CHRIST CHURCH OF ORLANDO (MINOR PLAT)

SUMMARY

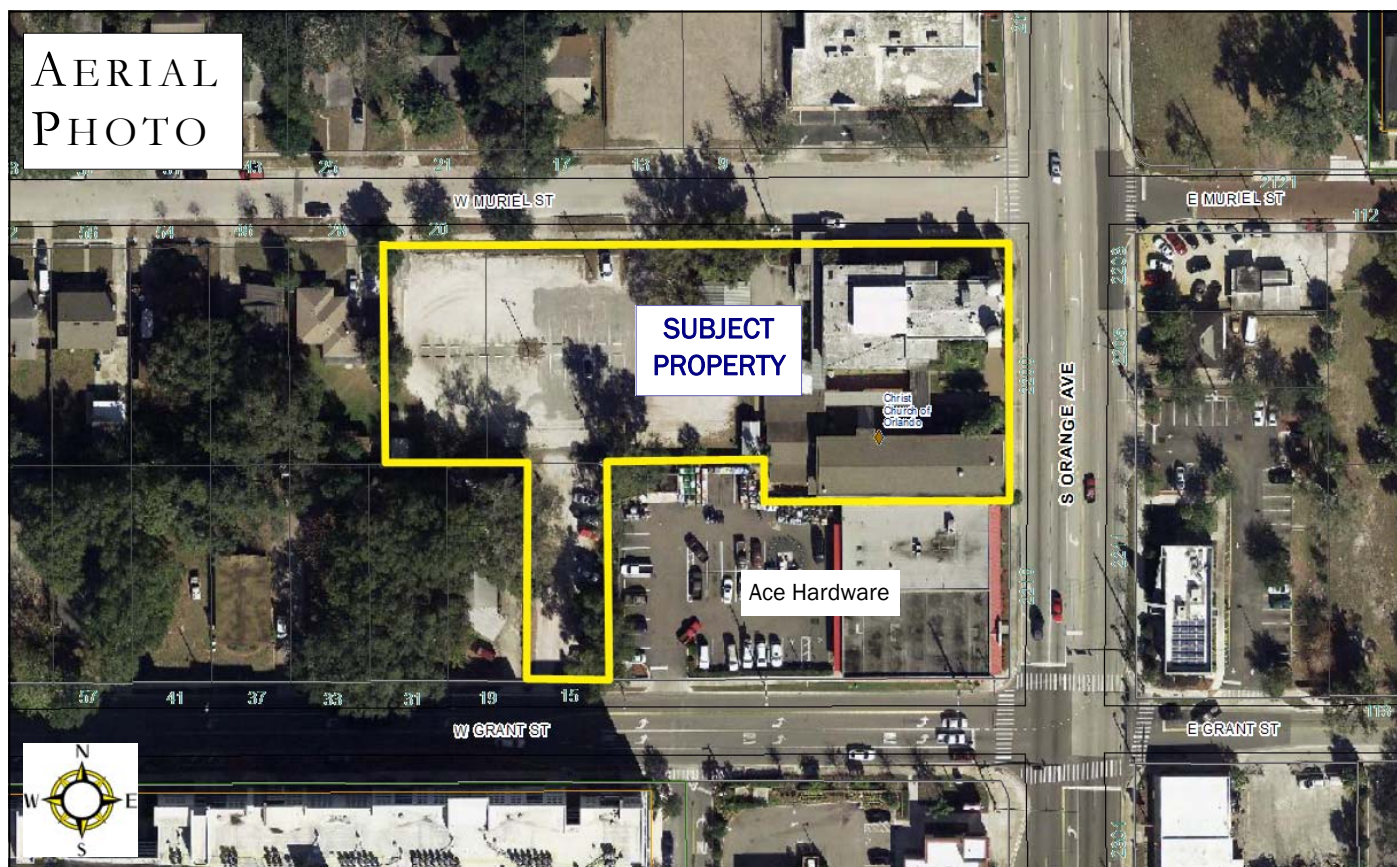
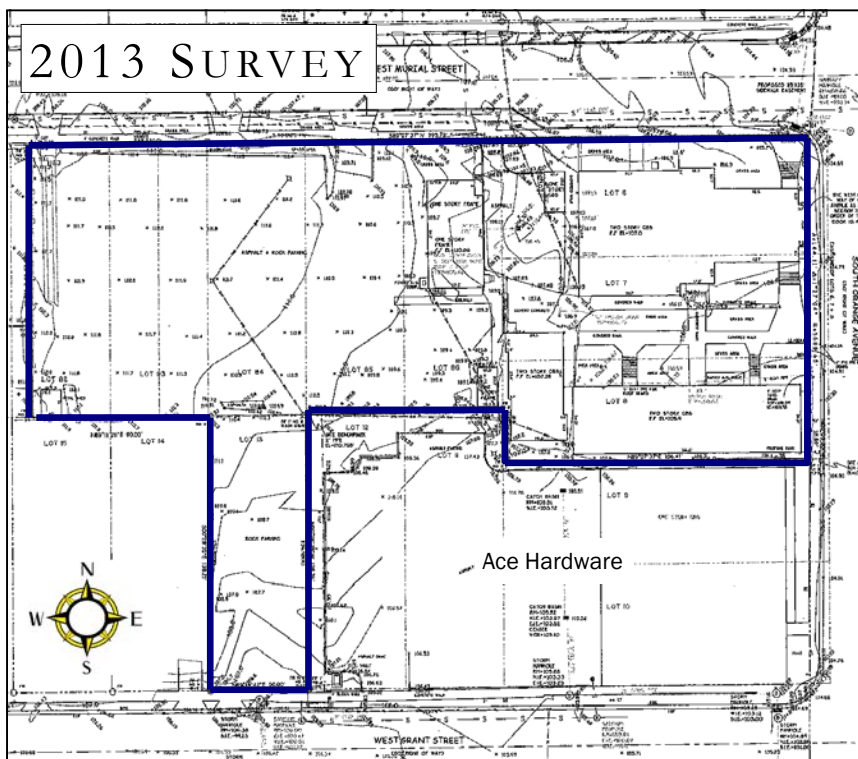
- 1) The lot must be numbered "Lot 1"
- 2) Either correct the book and page number shown on the mortgagees consent or remove the mortgagees consent in its entirety and provide a joinder and consent form with the correct mortgage book and page numbers.
- 3) The dedication block must be corrected with the appropriate title holder information.
- 4) "The City of Orlando" must be added to the subtitle.
- 5) All contiguous properties must be identified by subdivision title, plat book, and page number.
- 6) There is a driveway easement recorded in 10731/5454 shown on the certificate of title that must be shown on the plat.

1. The proposed driveway location or width does not comply with LDC requirements; however, since there are no alternative locations at this time, the proposed driveway will be approved with the following condition: "If, in the future, the adjacent property is redeveloped or substantially improved/enlarged as a compatible use, and the possibility of a joint-use driveway becomes available, the Owner/Applicant shall enter into the joint access easement agreement with the adjacent property to the southeast. The joint-use driveway shall then be constructed, and the property owner shall agree to close and eliminate the substandard driveway."

2. Cross-Access Easements - LDC Sections 61.108 - 61.113 provides the minimum requirements for cross-access corridors. The subject development shall provide cross-access easements to the adjacent properties to ensure that the parking, access, and circulation may be easily tied in to create a unified system (see CUP2014-00007).
